MEMORANDUM TO THE SITE FILE
Elmendorf Air Force Base
Operable Unit 6

Statement of Purpose

The purpose of this document (Memorandum to the Site File) is to present non-significant or minor changes to the Record of Decision (ROD) signed for OU 6 and Source Area SS19 at EAFB. The minor changes to the OU 6 ROD involve modifying the sampling frequency of groundwater wells. Other components to the OU 6 selected remedy will not be affected by this minor change.

Attachment 1. Basewide Monitoring Program Well Sampling Frequency Decision Guide.

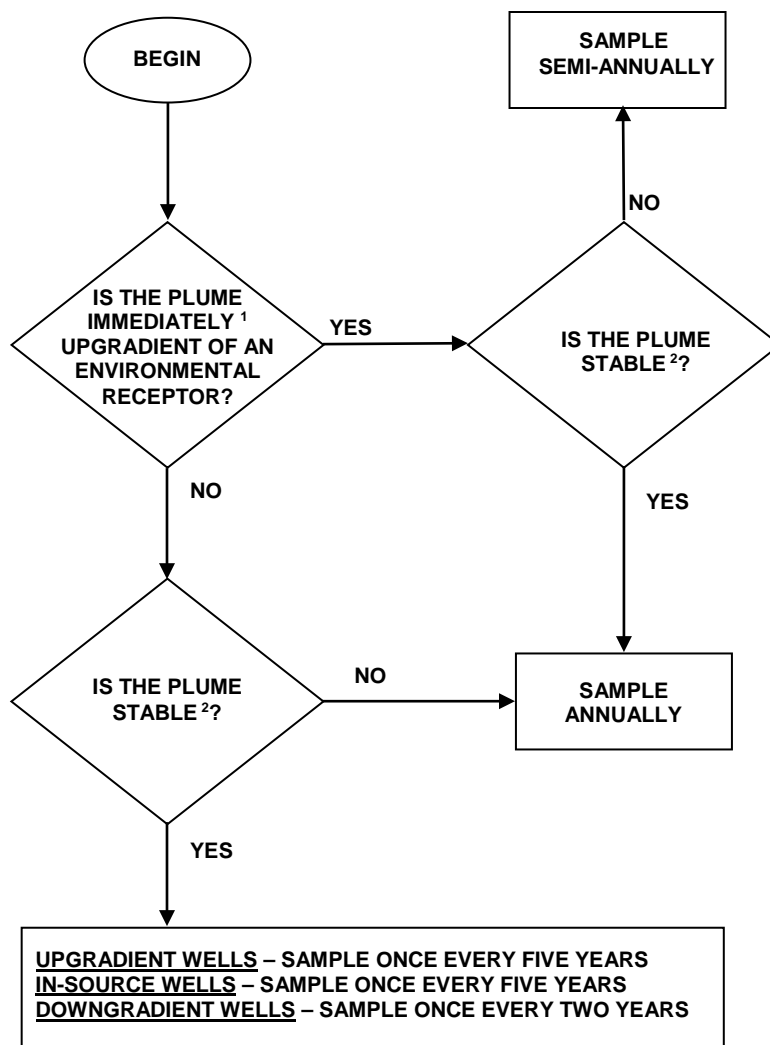
URS presented the new proposed Basewide decision guide for determining sampling frequencies for monitoring wells. Proposed monitoring frequencies are based on position of plumes relative to environmental receptors. Plumes immediately upgradient of a receptor were proposed for annual sampling. Plume not immediately upgradient of a receptor were proposed for sampling every 2 to 5 years.

EPA pointed out that this guide is only appropriate for stable plumes and suggested that we add a box to include a decision for unstable plumes. Unstable plumes should be sampled semi-annually if upgradient of a receptor or within the early warning line in OU 5.

1. Seeps are sampled annually, unless they exceed cleanup levels in which case they are sampled quarterly.
2. Wells with historical free product will be monitored annually for free product occurrence. Active product recovery will continue in wells with recoverable free product.
3. Sampling frequencies can be modified as needed to support site closure or modeling results.
4. Surface water sampling at OU 5 (Ship Creek) will be performed annually.
